Determination 2016/014

Regarding access and facilities for people with disabilities to a gym in an altered existing two-storey building at 38 Richard Pearse Drive, Airport Oaks, Auckland

Figure 1: Site plan ground floor (approx. and not to scale)

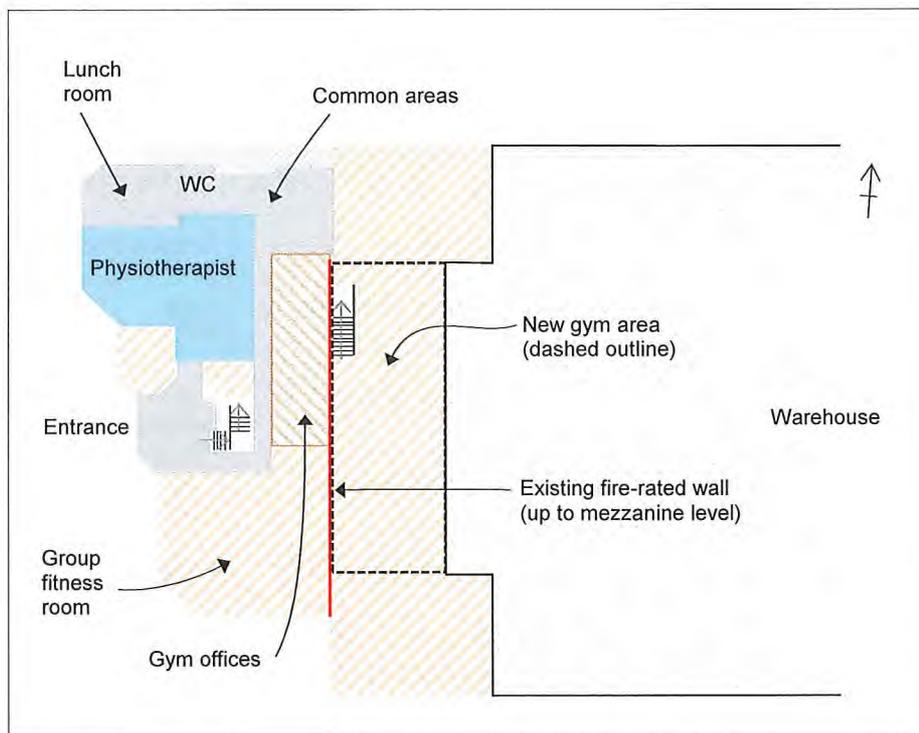
- 2.4 There is no direct access from the entrance area and physiotherapist and offices, to the newer gym area to the east (“the new gym area”). To access this area, staff and gym users must first ascend the flight of stairs leading from the entrance area to the mezzanine, and then descend into the new gym area via the second set of stairs constructed as part of the alterations (refer Figures 1 and 2 over page).

- 6.3.2 To get to the new gym area, users must first ascend stairs to the mezzanine floor, and then descend a second flight of stairs to the new gym area. (I assume that this arrangement was reached to avoid having to create a door through the existing fire wall, which sits between the original gym and the new gym area.)
- 6.3.3 As there is no accessible route to the new gym area, the alterations do not comply with Clause D1 of the Building Code to the extent required by section 17 of the Act.

- 6.4.1 From the consented plans the ground floor shower does not appear to be accessible and no accessible facilities are provided on the mezzanine level.
- 6.4.2 As noted in paragraph 2.2, the single accessible toilet is accessed via a rather circuitous route to an area not immediately associated with the gym and the route includes navigating a turnstile. In addition, the only path to the accessible toilet from the entrance area appears to be through the group fitness room, which might pose difficulties for a person with disabilities if a class was in session.
- 6.4.3 In my view the personal hygiene facilities at the applicant's gym do not satisfy Clause G1 of the Building Code to the extent required by section 112 of the Act has not been met.

Figure 2: Mezzanine level (approx. and not to scale)

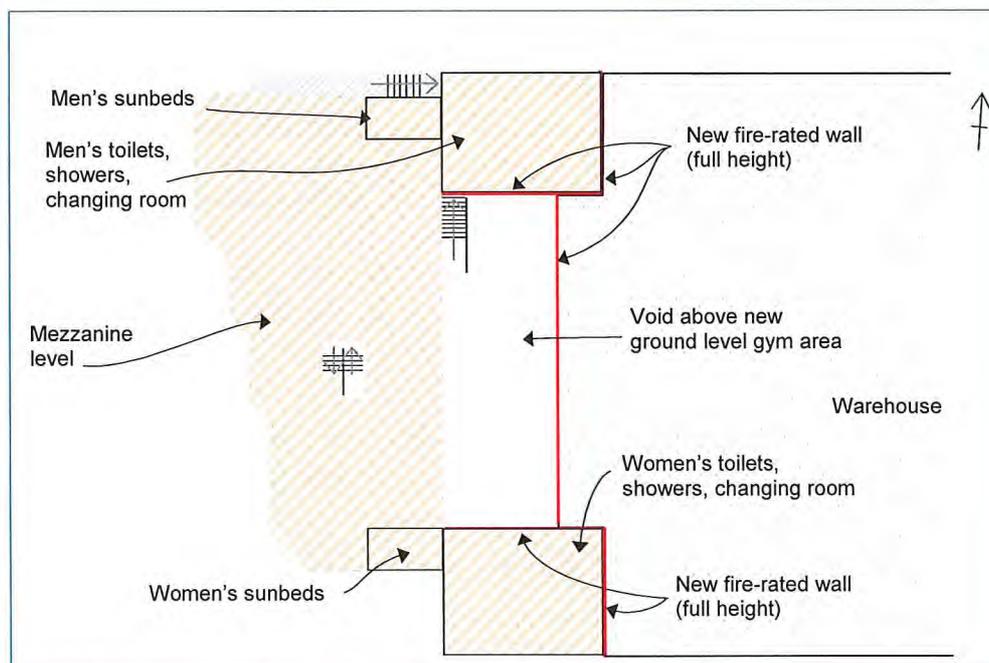
- 2.6 The mezzanine floor covers an area of approximately 593m² and consists largely of open, un-partitioned space and is accessed by three separate sets of stairs, one of which leads up in two flights from the building’s entranceway. It contains two sets of sanitary facilities (one for men and one for women) at either side of the building, which contain toilets, showers and changing areas. There is a single step from the changing area to the shower facilities. None of these facilities are designed to be accessible for people with disabilities.

- 6.3.1 The alteration work included the provision of 10 showers and 5 toilet cubicles for use by gym members. There are no accessible facilities provided and there does not appear to any reason why the sanitary facilities could not have included one or more accessible showers and toilets. The alterations do not comply with Clause G1 of the Building Code to the extent required by section 17 of the Act.

- 6.4.7 However, my own calculations, based on the approved consented drawings (see paragraph 3.3) generally accord with the original 2006 fire report, and mean that a lift would be required as the occupancy level of the upper floor is above 40 and the floor area is not less than 400m².
- 6.4.8 Even using the lesser revised area of 398m², applying an occupancy load of 0.35⁹ users/m² that was set out in the Acceptable Solution current at the time, the calculated occupant load would still be 139 – significantly higher than 40 occupants set out in D1.3.4(c)(iii).
- 6.4.9 The equivalent figure from the Acceptable Solution¹⁰ currently in force is 0.2 users/m², which for an area of 449m², gives a design occupancy of 90.
- 6.4.10 These figures are all well in excess of the 40-person occupancy limit stated Clause D1.3.4(c)(iii) beyond which a lift is required.

- 6.4.17 In this case it is clear the mezzanine floor is well in excess of the area requiring a lift under NZS 4121, and the design occupancy provided for in D1.3.4(c)(iii). The benefits to be obtained from installing the lift mean that people with disabilities will be able to gain access to what is the main gym area; as well the changing rooms etc. Modification of the ground floor layout would also be required to enable those with ambulant disabilities to access the new gym area.

- 6.4.19 I conclude therefore that a lift is required and that neither the alterations, nor the existing building after the alterations comply with Clause D1.
